**Subject: MHI's Response to US-APWR DCD RAI No. 721-5535 Revision 2 (SPR 09.01.04)**

**Reference:** 1) "Request for Additional Information No. 721-5535 Revision 2, SRP Section 09.01.04 – Light Load Handling System (Related to Refueling) - Application Section: 9.1.4", dated March 21, 2011.

Response to Request for Additional Information No. 721-5535  
Revision 2

**RAI NO.:** NO. 721-5535 REVISION 2  
**SRP SECTION:** 09.01.04 – LIGHT LOAD HANDLING SYSTEM (RELATED TO REFUELING)  
**APPLICATION SECTION:** 09.01.04  
**DATE OF RAI ISSUE:** 03/21/2011

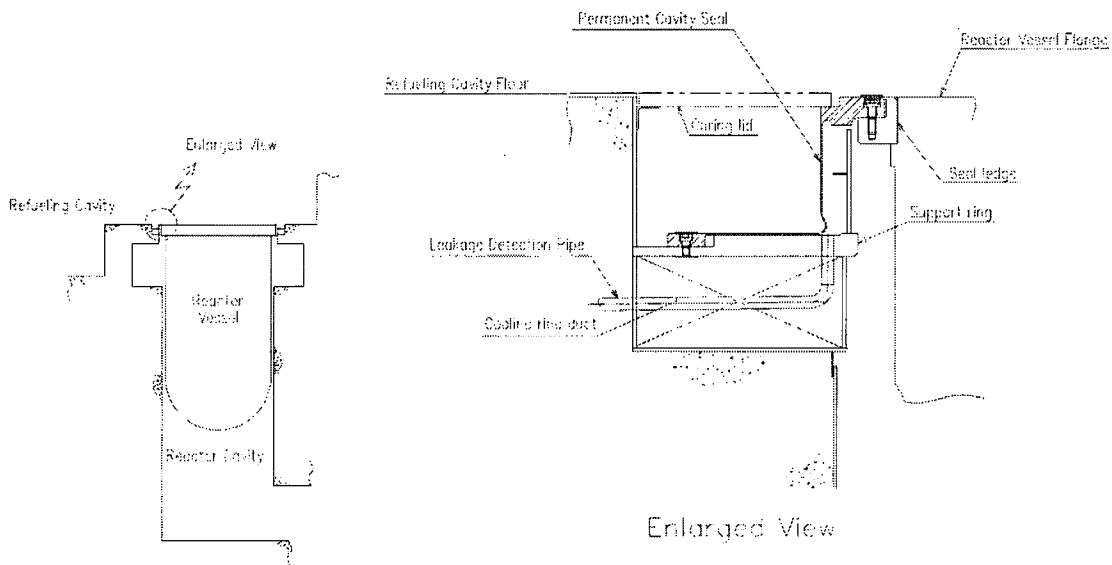
4. The response to RAI 09.01.04-21 provided a drawing that included the leakage detection design. From the information contained in the drawing and description in the RAI response, it was not clear to the staff that all of the expected leakage would be directed into the leakage detection pipe. Additional information regarding the leakage detection design is needed in the DCD, including assurance that all leakage from the PCS will enter the leakage detection pipe.

MHI will provide additional information regarding the leakage detection design in Tier 2 of DCD Chapter 9 Section 9.1.4.2.1. See the fourth paragraph in the new Section 9.1.4.2.1.13 "Permanent Cavity Seal (PCS)" to be added.

Leakage detection systems are utilized for the PCS. Two leakage detection pipes are installed under the ring-shaped PCS directly opposite each other across the reactor vessel. Wherever around the seal leakage from the PCS should occur, the leakage water flows and accumulates into an annular space between a vertical cylindrical plate, which is attached to support ring, and the PCS, and eventually flows into one or both of the detection pipes. Once water flows into the leakage detector via the leakage detection pipe, the leak detection system provides an alarm signal to alert operators in the MCR and in the vicinity of the fuel handling system that an abnormal water level condition exists in the refueling cavity.

- Add the following figure in Tier 2 of the DCD Chapter 9 Section 9.1;
